DURHAM COUNTY

I-40 and Miami Blvd.

Date: April 4, 2017	County: Durham
Interchange: I-40 and Miami Blvd.	
Location (exit ramp): EB Exit Ramp

I-40 WB Exit Ramp at Airport Blvd.

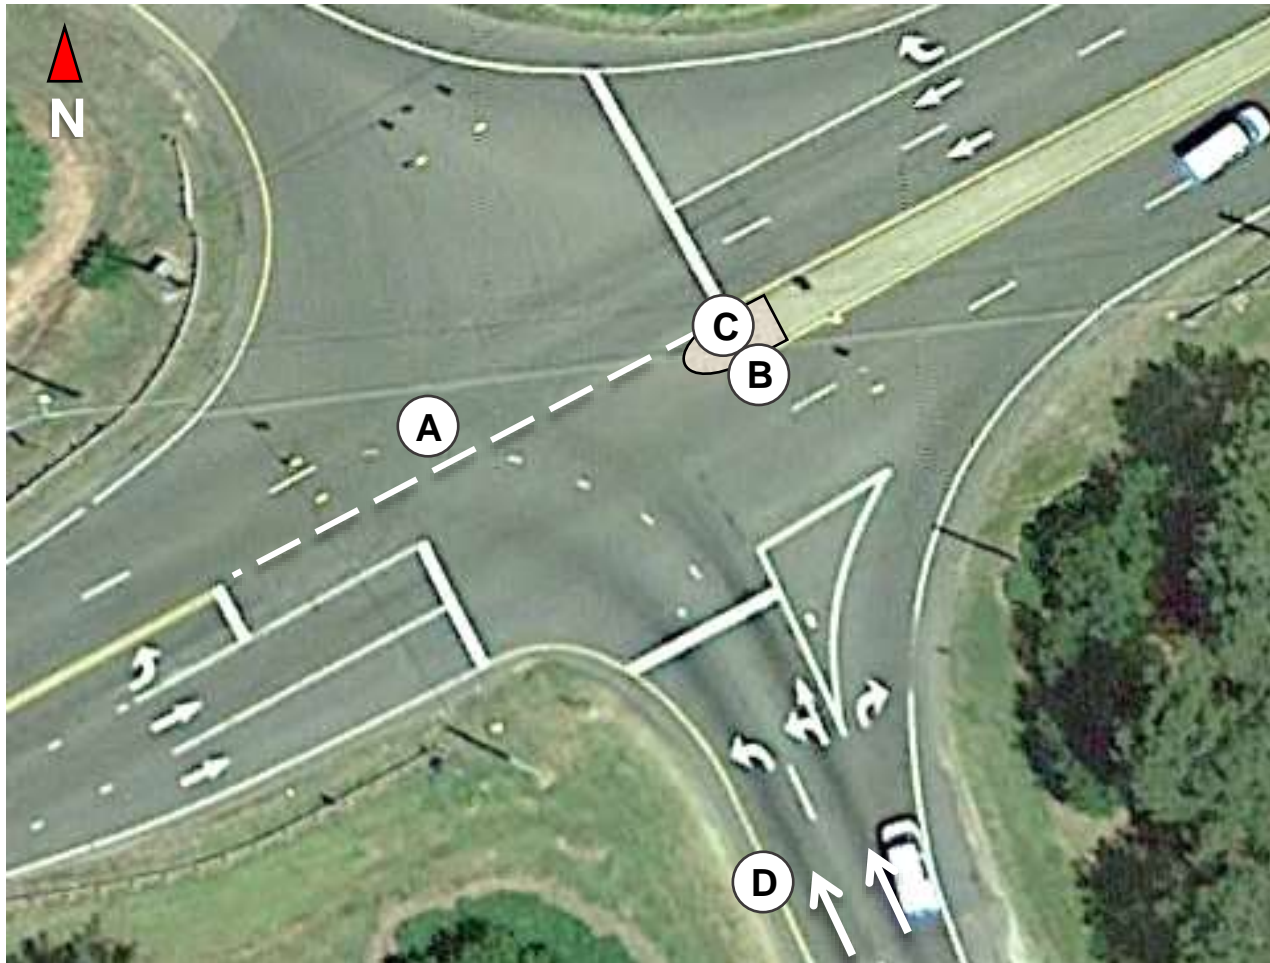
Add straight dashed guide lines through intersection along left side of Southbound Airport Rd. to mitigate wrong way left turn.

- A. Add dashed lines through intersection
- B. Extend raised median
- C. Add No Left Turn sign
- D. Add Wrong Way arrows

I-40 EB Exit Ramp at Gorman St.

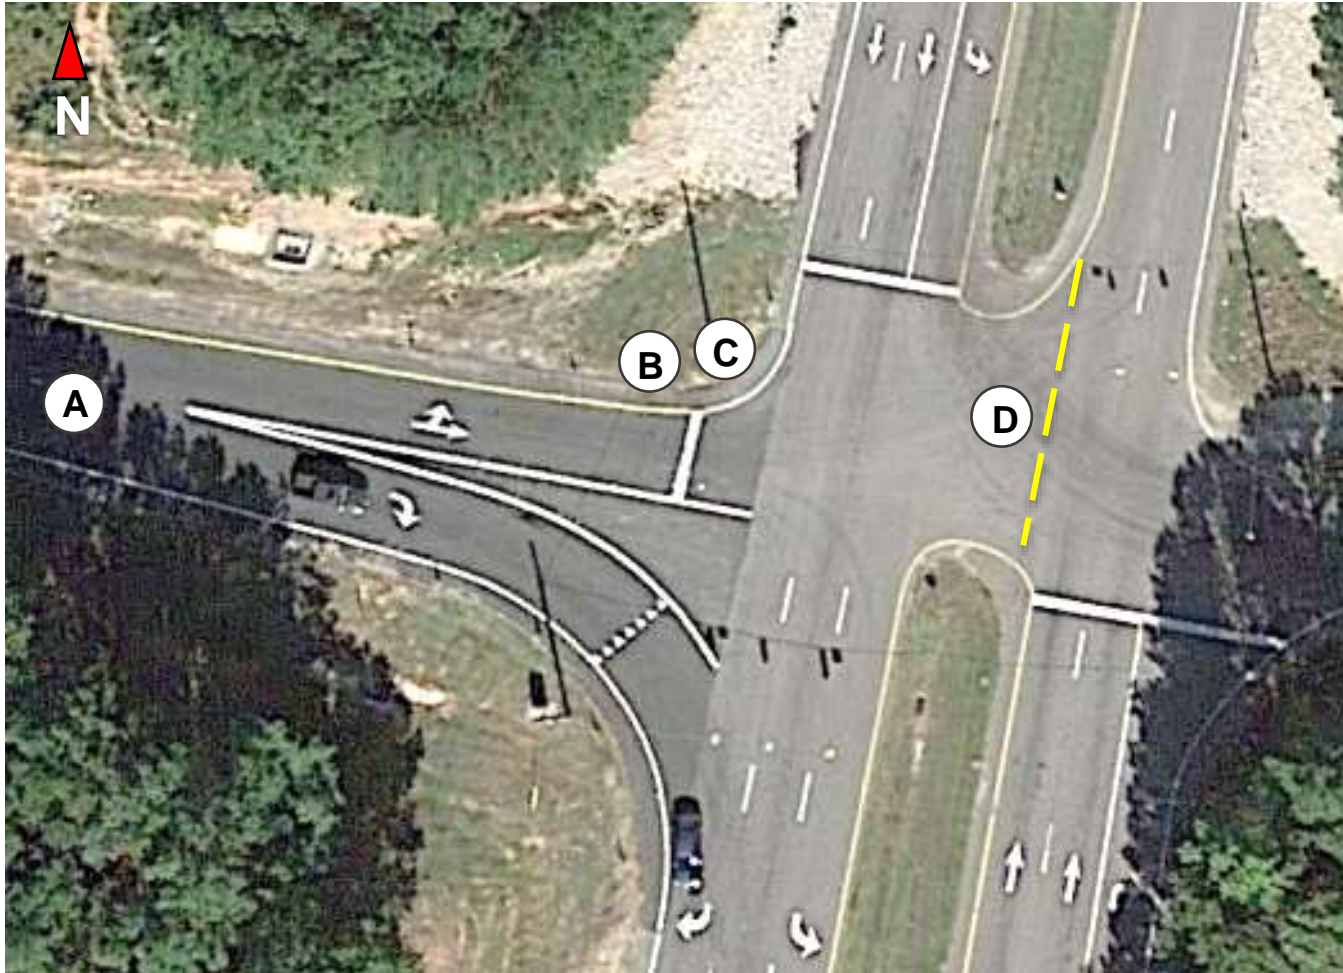
Straight dashed lines along left side of Northbound lane at crossroad median break may help mitigate wrong way left turn.

- A. Add Wrong Way arrows
- B. One-Way sign
- C. Add Do Not Enter sign
- D. Add straight dashed lines through intersection

I-40 WB Exit Ramp at Gorman St.

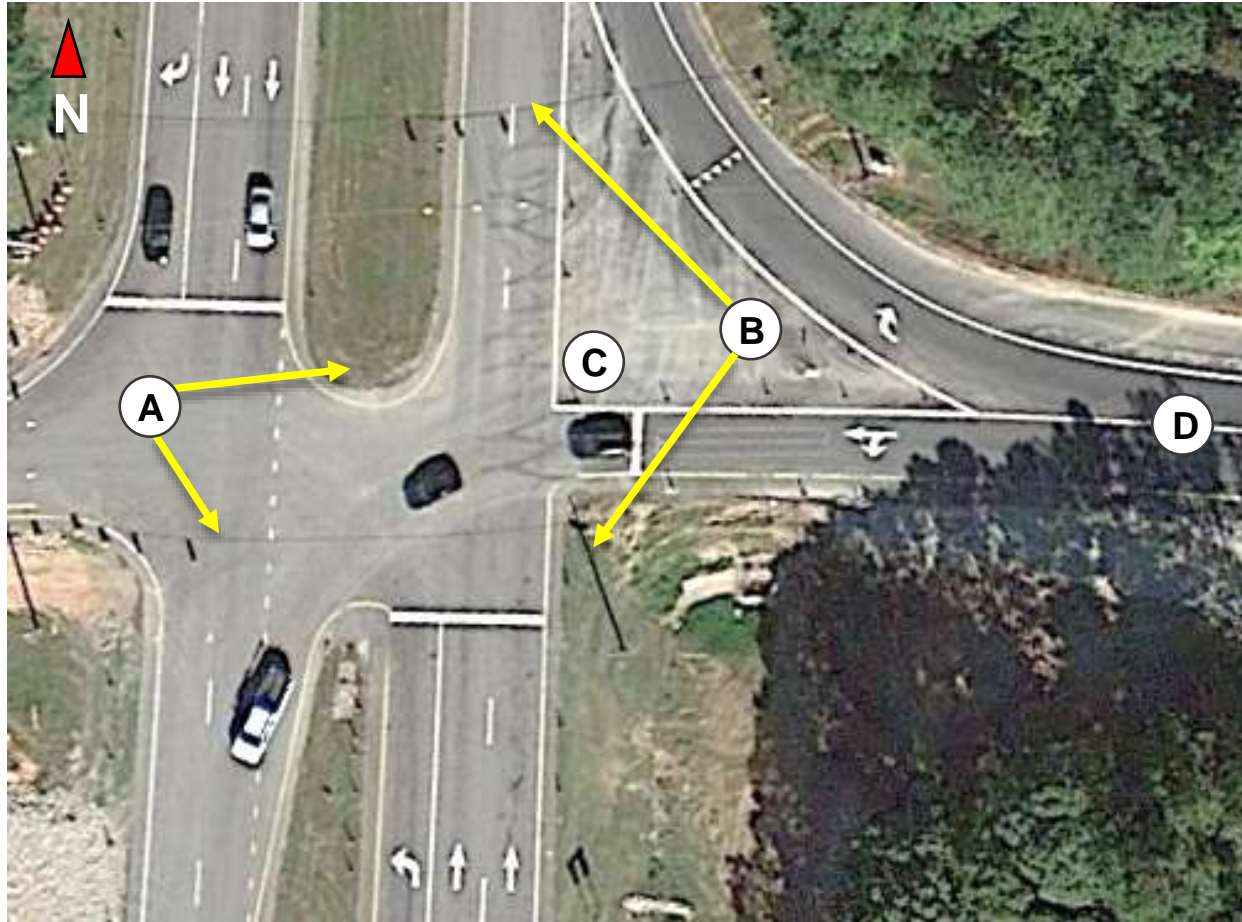
- A. Add No Left Turn signs (corner and overhead span wire)
- B. Add No Right Turn signs (corner and overhead span wire)
- C. Add Do Not Enter sign
- D. Add Wrong Way arrows

I-40 EB Exit Ramp at Rock Quarry Rd.

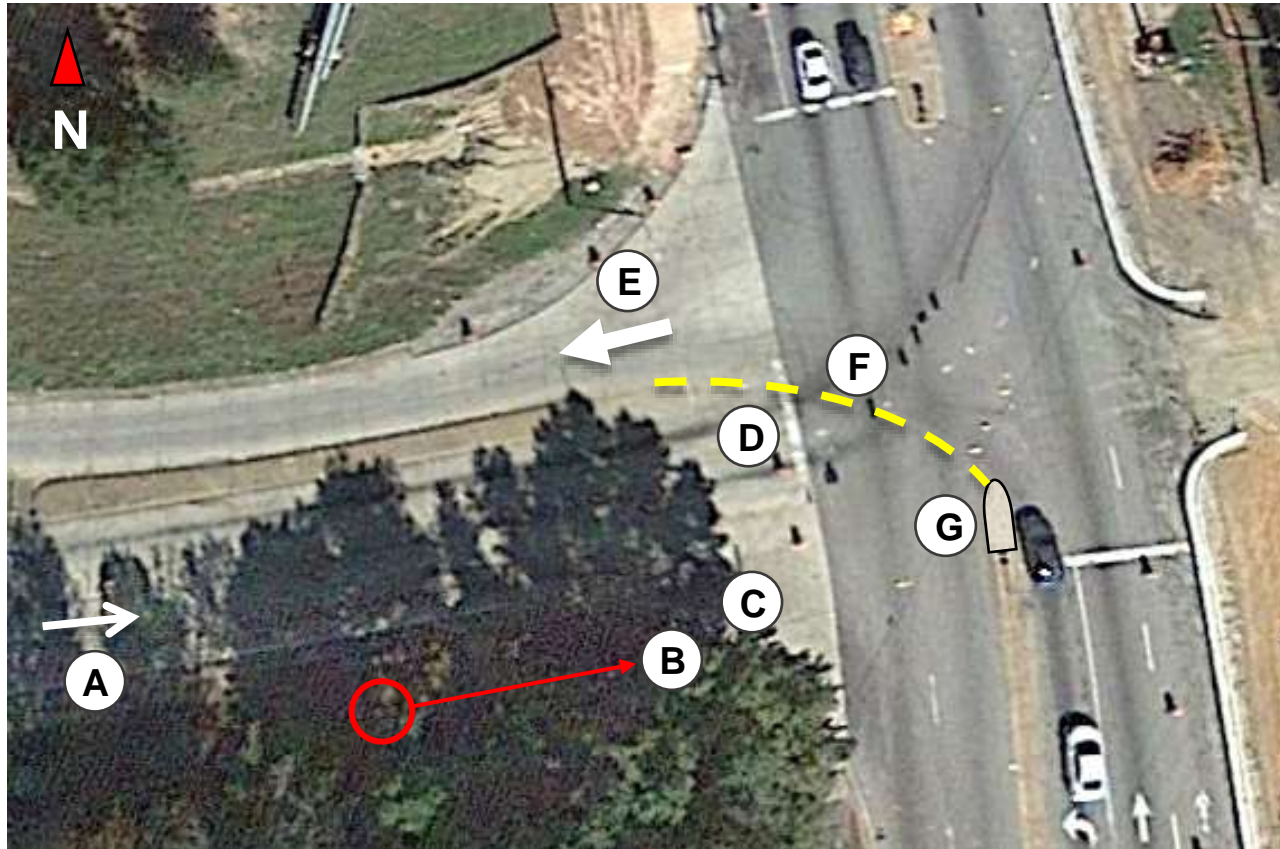
- A. Add wrong way arrows
- B. Replace Wrong Way sign and move to outside shoulder
- C. Add One-Way sign
- D. Repaint stop bar
- E. Add arrow indicating correct freeway entrance point
- F. Add dotted lane line extension through intersection
- G. Extend raised median

I-40 EB Exit Ramp at Saunders St.

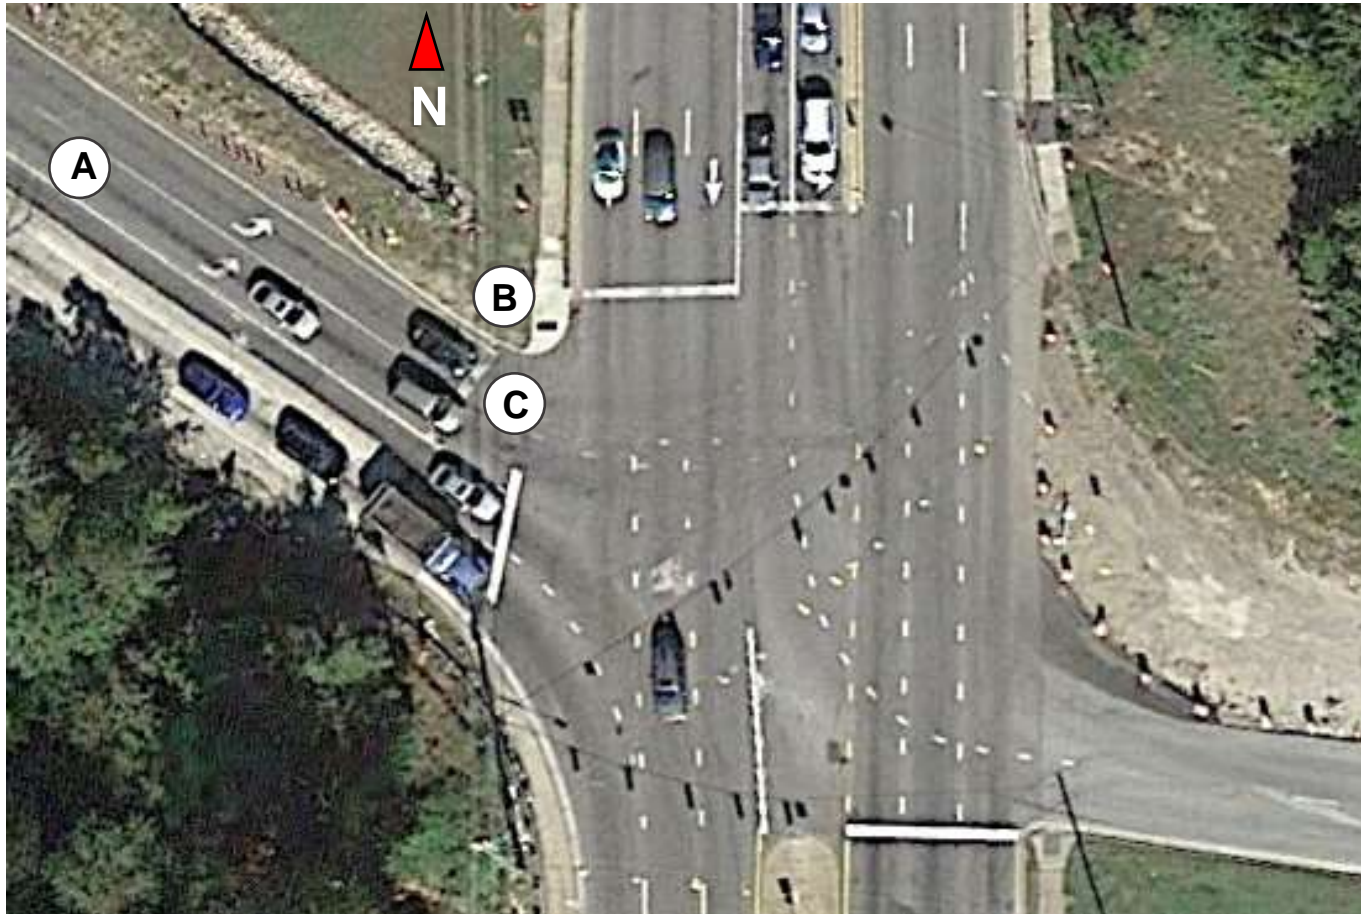
- A. Add Wrong-Way arrows
- B. One-Way sign
- C. Repaint stop bar

I-540 EB Exit Ramp at Falls of Neuse Rd.

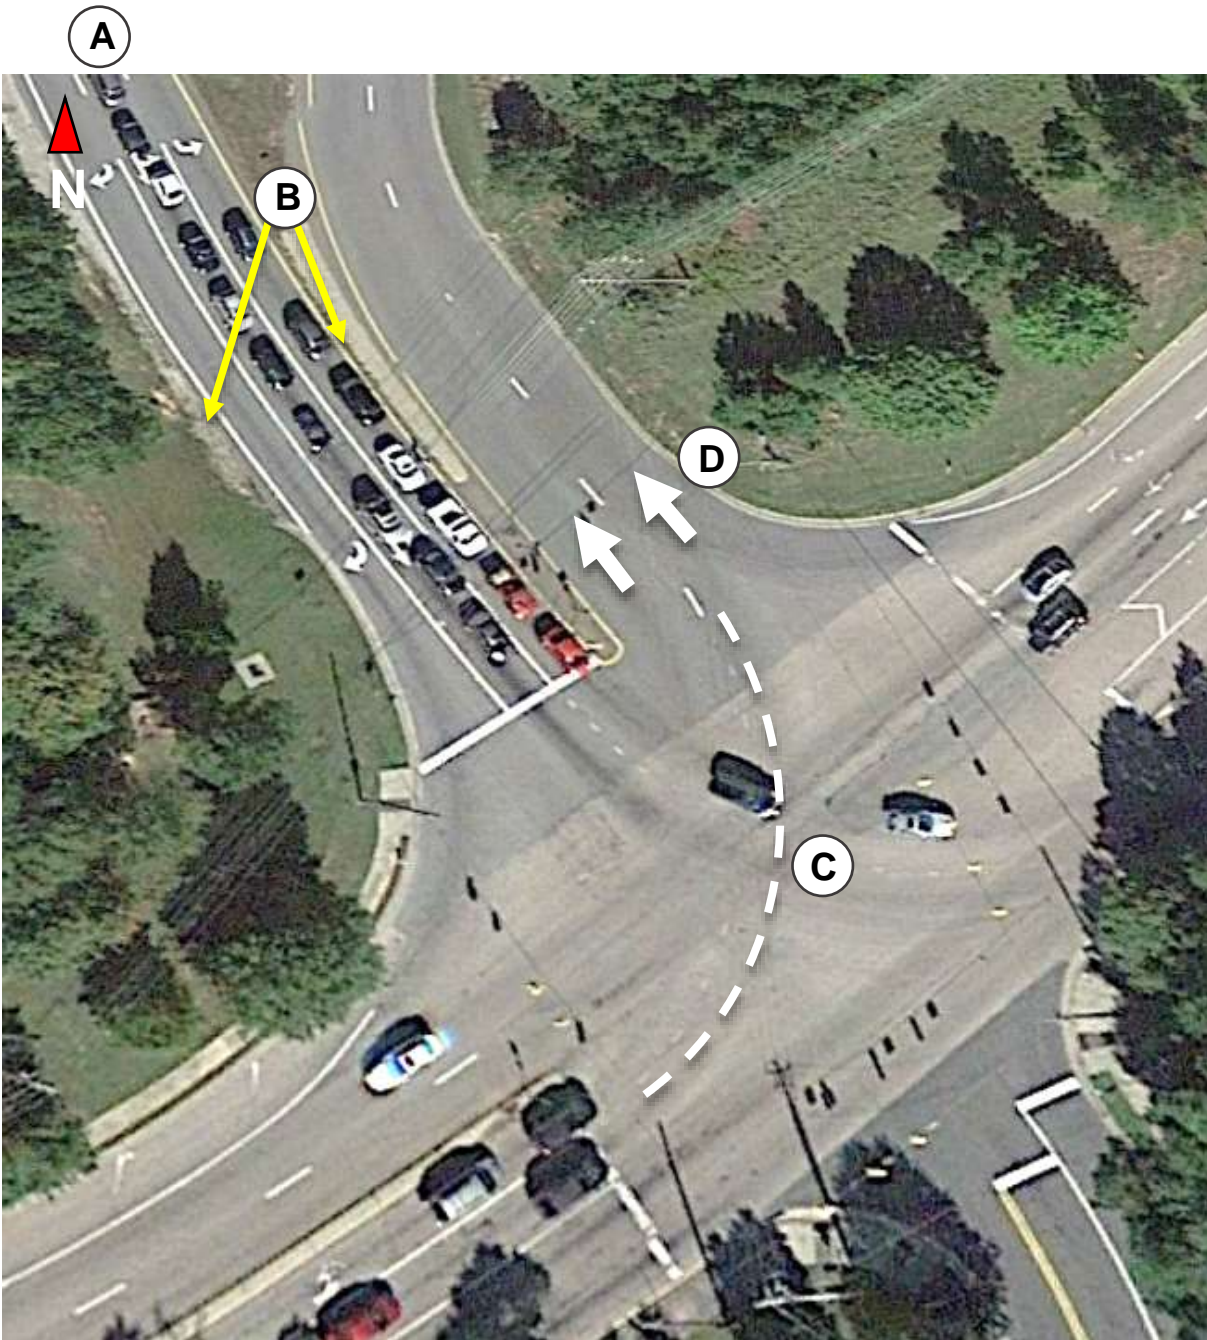
- A. Add Wrong-Way arrows (not shown)
- B. Add Wrong-Way signs
- C. Renew dotted lane line extension through intersection
- D. Add arrow indicating correct freeway entrance point

I-540 WB Exit Ramp at Falls of Neuse Rd.

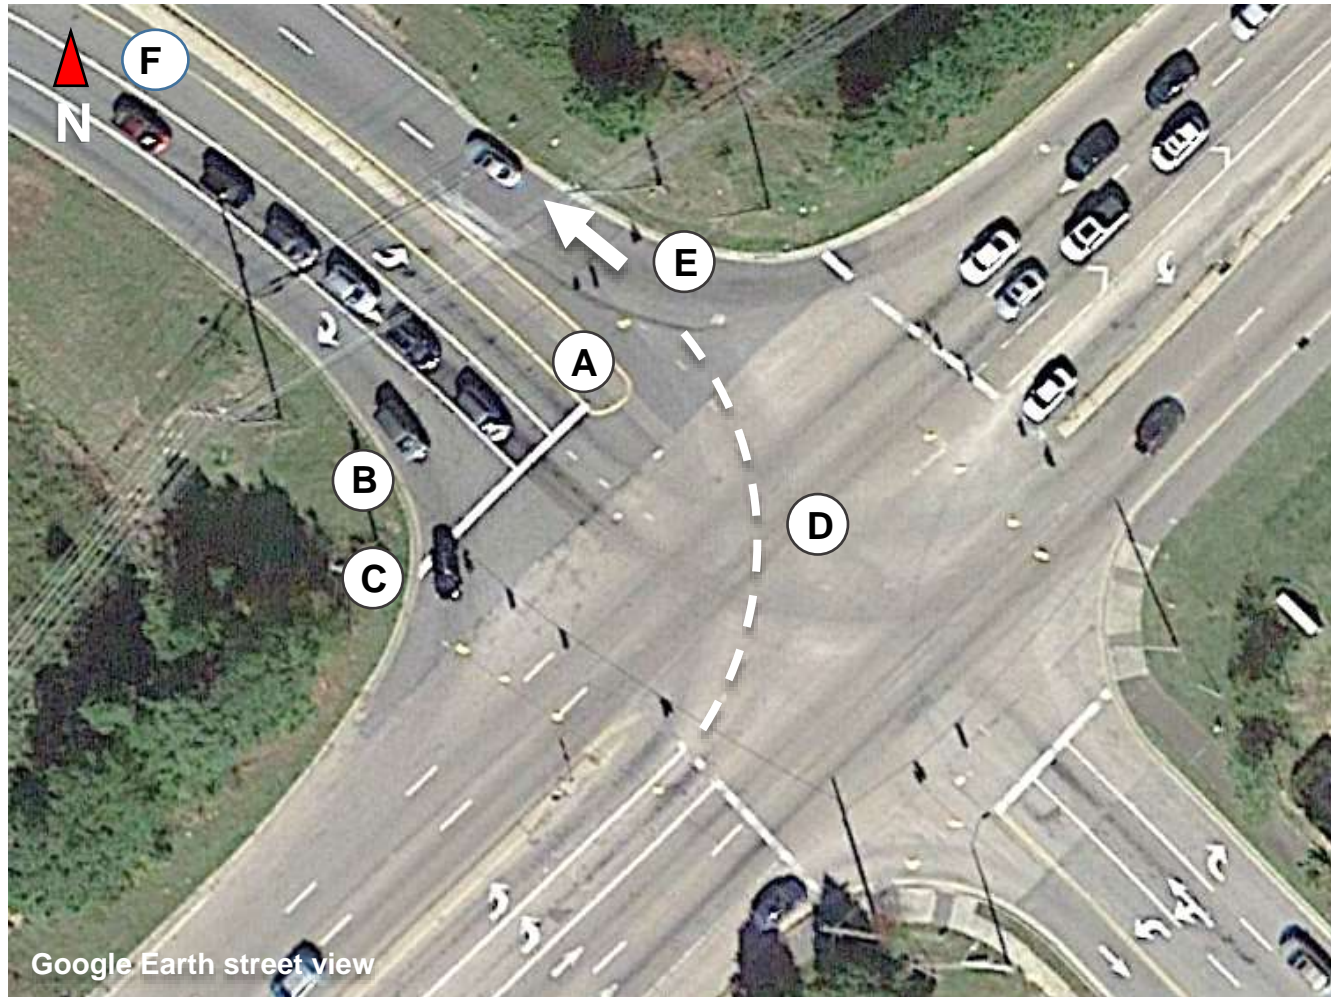
- A. Extend raised median, increase visibility, add splitter sign
- B. Add Do Not Enter sign
- C. Consider One Way sign
- D. Add turning guide lines
- E. Add arrow indicating correct freeway entrance point
- F. Add Wrong Way arrows

US 1 NB Exit Ramp at NC 55

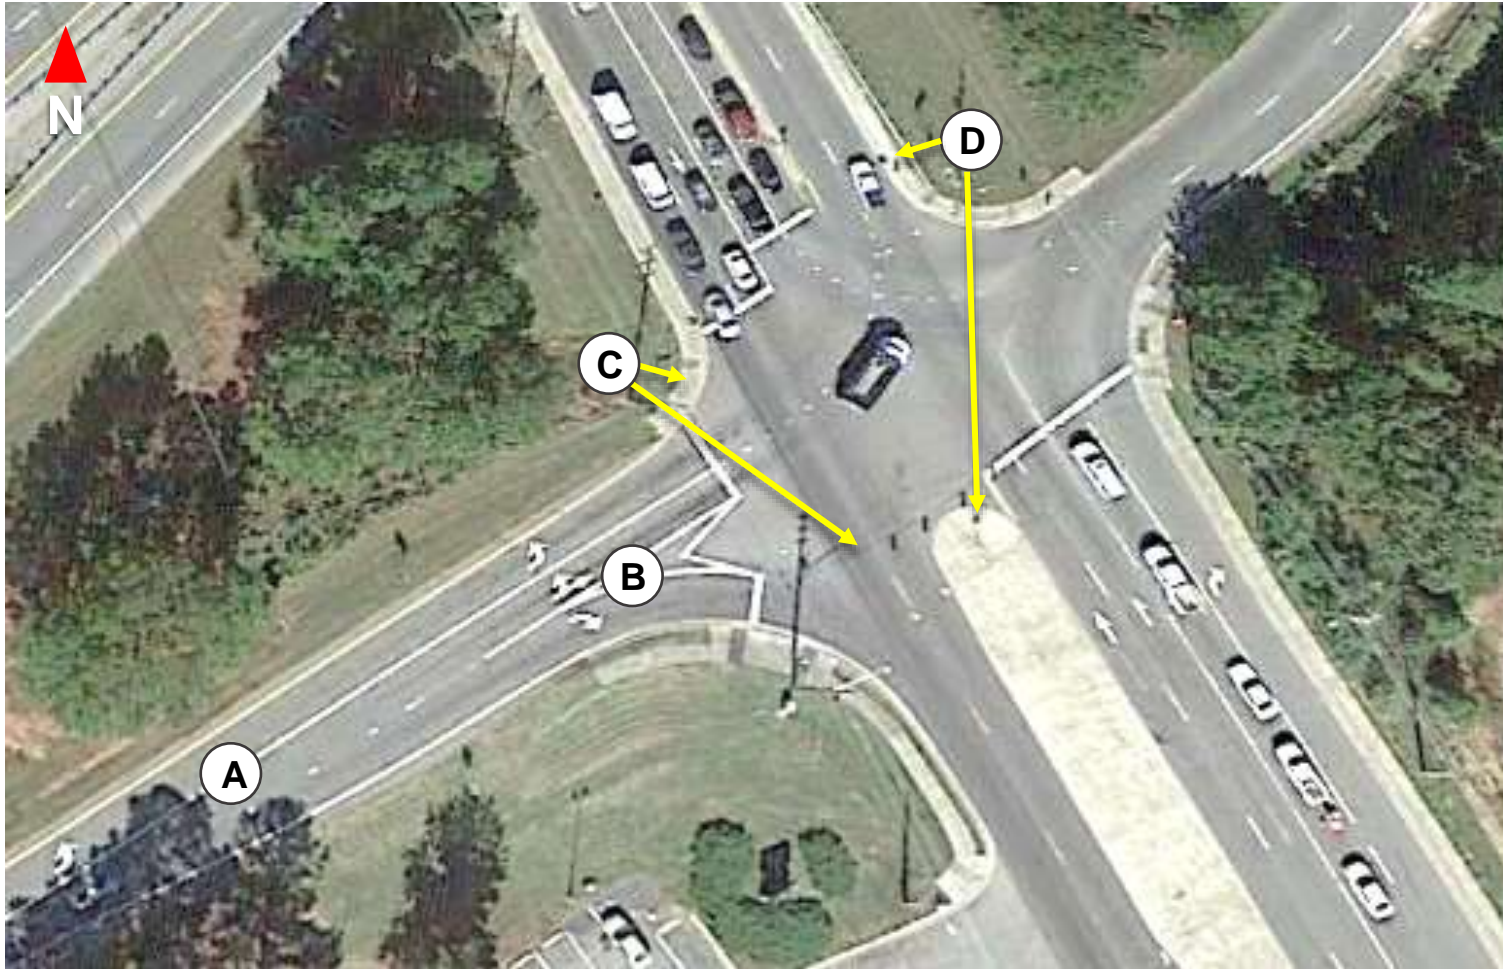
- A. Add Wrong Way arrows
- B. Convert flush splitter island to raised island
- C. Add No Right Turn signs (on corner and overhead span wire)
- D. Add No Left Turn Signs (on median and overhead span wire)
